ORIGINATION FORM

Proposed Revisions to a Standard Plans Index

Index Number: 102-615

Index Title: Multilane Roadway, Intersection Work

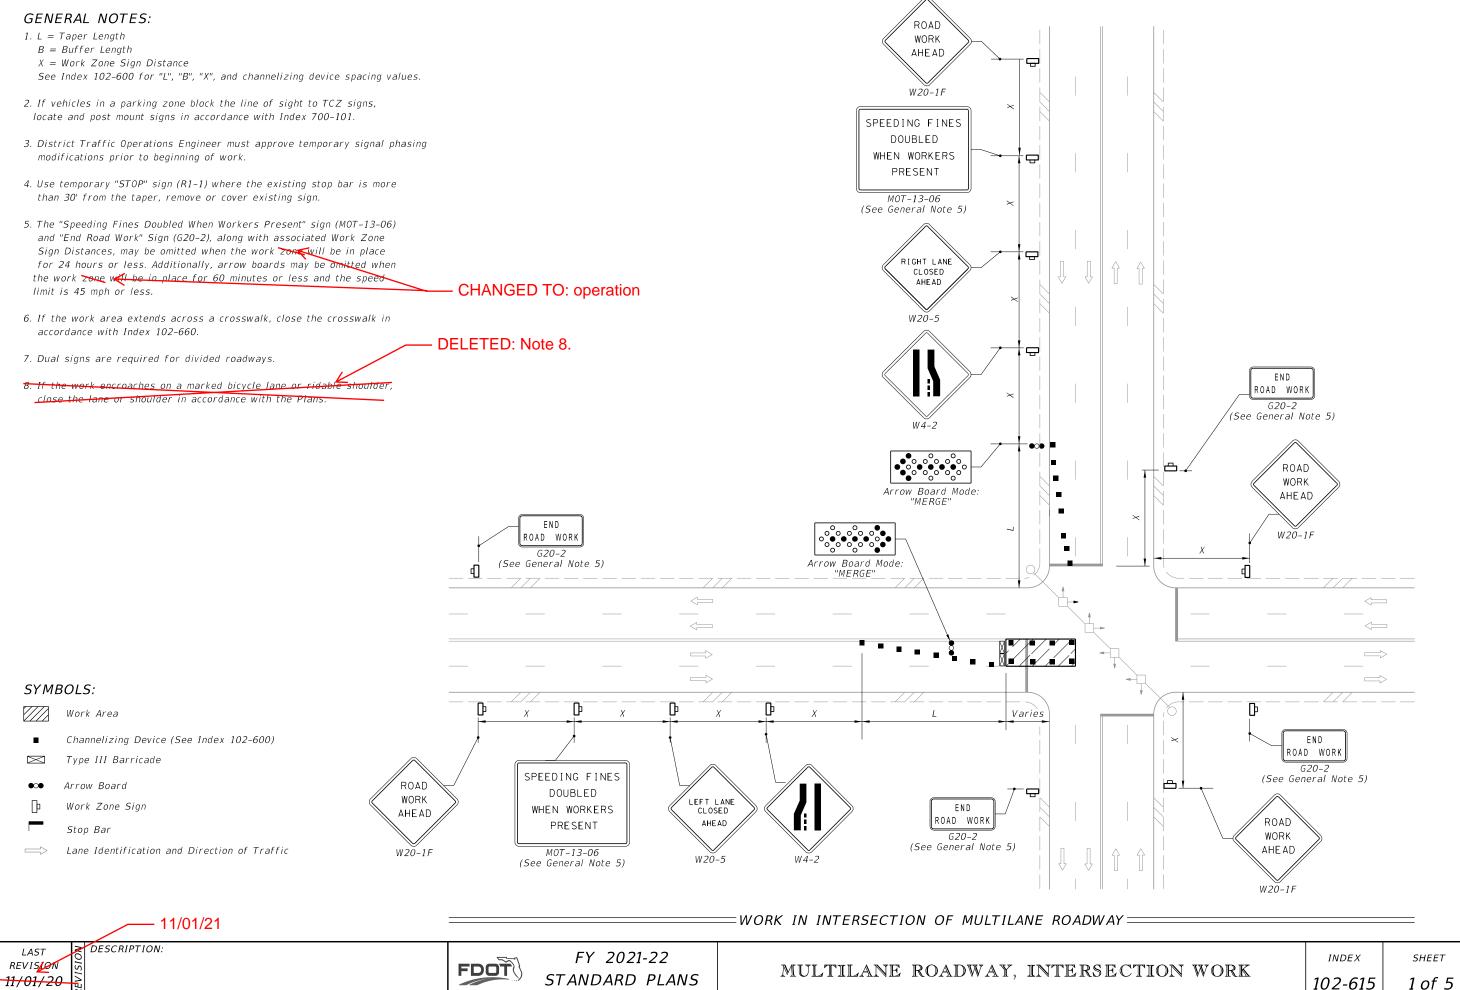
Sheet 1: Changed Note 5 - "work zone" to "work operation";

Deleted Note 8.

Added Arrow Board Mode: "Merge" to the detail.

The duration provisions of the index are intended to apply to the length time needed to perform the specific temporary traffic control work "operation" shown, which is independent of the duration of an overall construction project. The term "Work Zone" is being replaced with "Work Operation" to clarify the intent.

= MULTILANE, WORK IN INTERSECTION CENTER LANE =

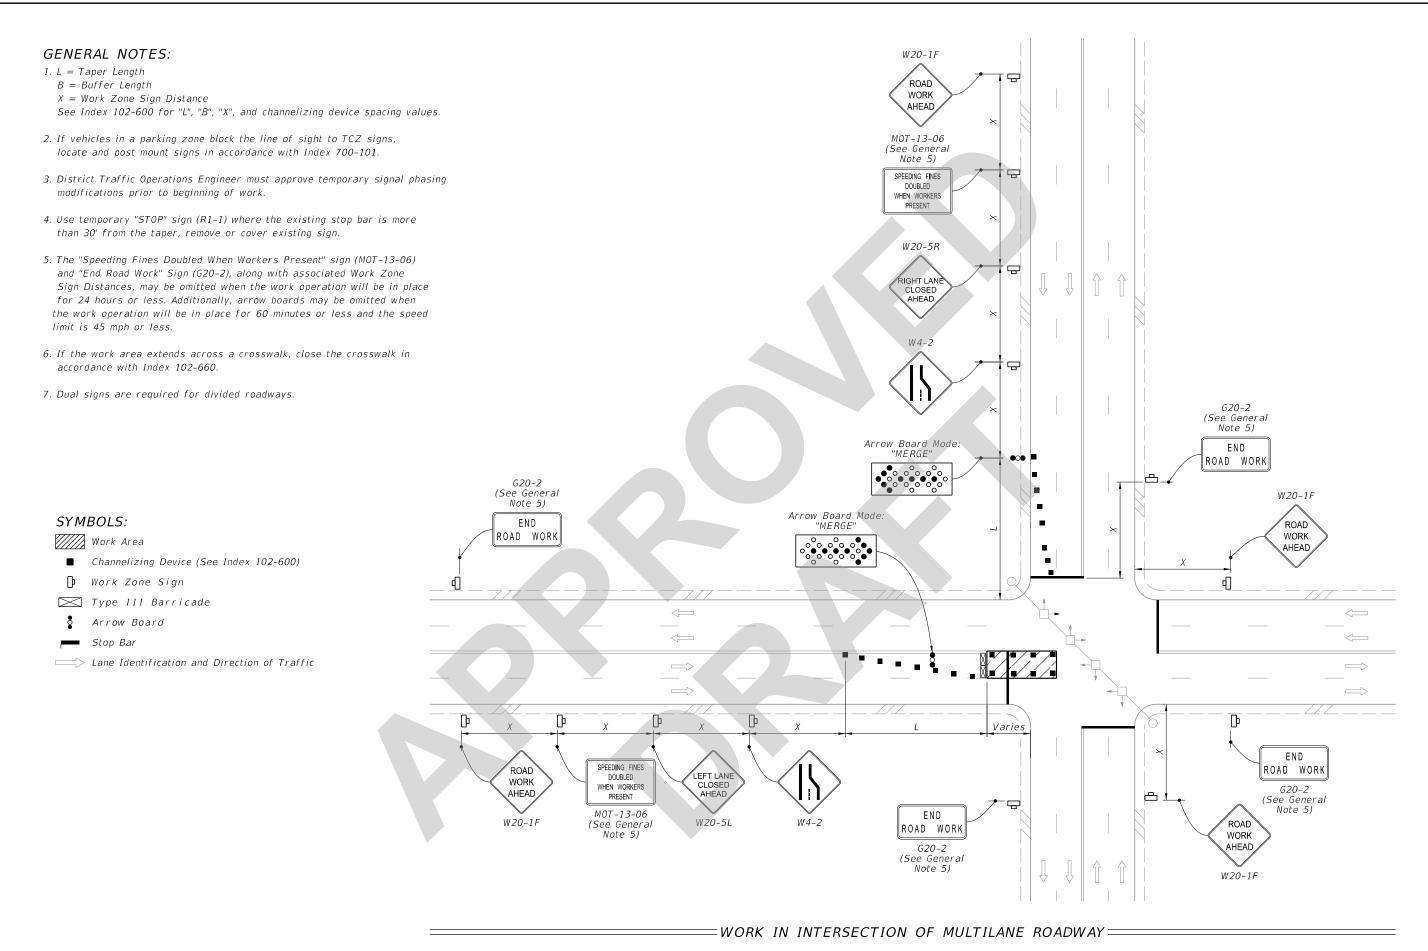
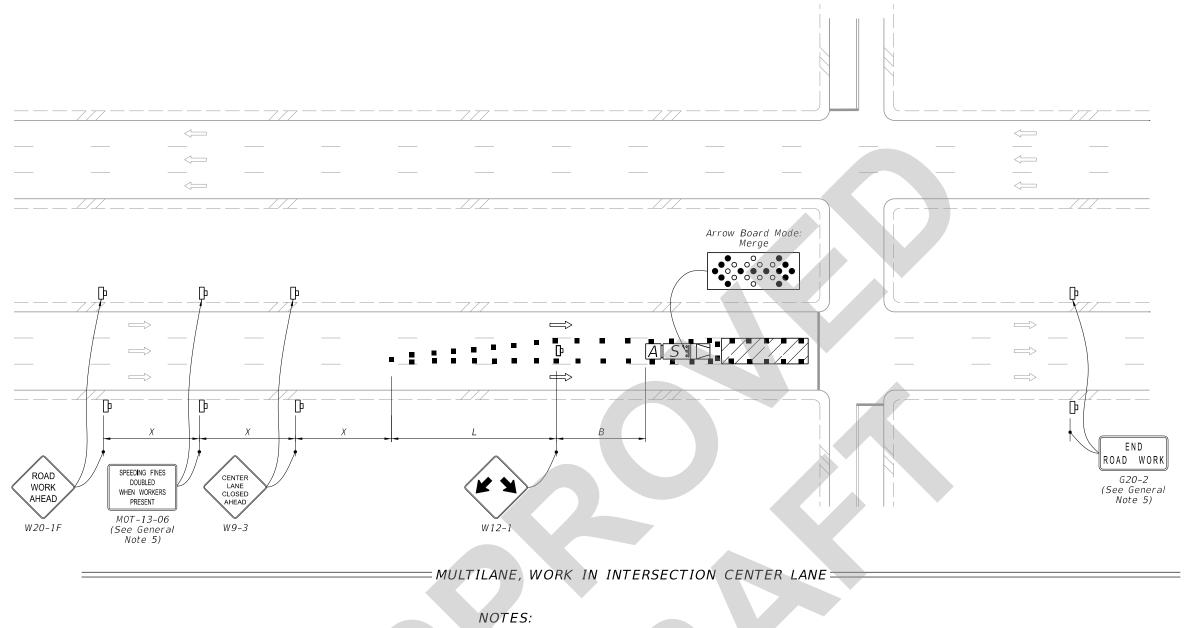
Sheet 4: Moved buffer zone and the associated dimension "B" before the Truck Mounted Attenuator in the work zone.

The buffer space was moved to be consistent with the MUTCD. MUTCD guidance says "When a shadow vehicle, arrow board, or changeable message sign is placed in a closed lane in advance of a work space, only the area upstream of the vehicle, arrow board, or changeable message sign constitutes the buffer space."
